UNITED STATES PATENT AND TRADEMARK OFFICE

APPLICATION NO.	FILING DATE	FIRST NAMED INVENTOR	ATTORNEY DOCKET NO.	CONFIRMATION NO.
09/989,277	11/20/2001	Frederic Lagace	CLW 2 0098-1-2	1192

Office Action Summary	Application No. 09/989,277	Applicant(s) LAGACE ET AL.	
	Examiner Tho v Duong	Art Unit 3743

DETAILED ACTION

Figure A: The modified figure corresponds to figure 1 with limitations shown.

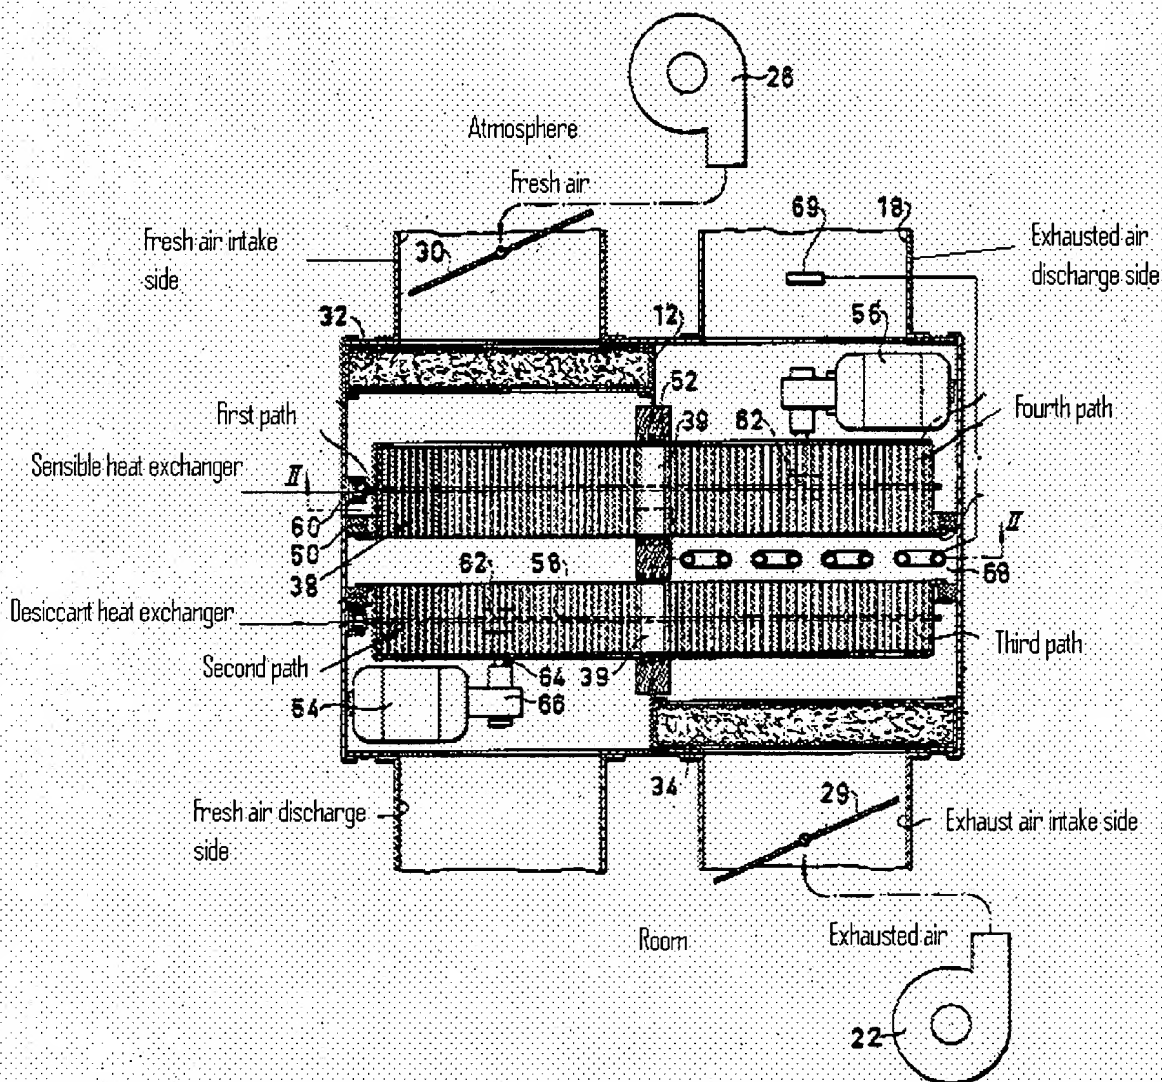
Claims 35-36 and 38-39 are rejected under 35 U.S.C. 102(b) as being anticipated by C. G. Munters et al. (US 3,125,157). Munters discloses (figures 1,2, A and column 2, line 39 –

column 4, line 50) the ventilation apparatus and the method for exchanging air between the interior and exterior of a building.
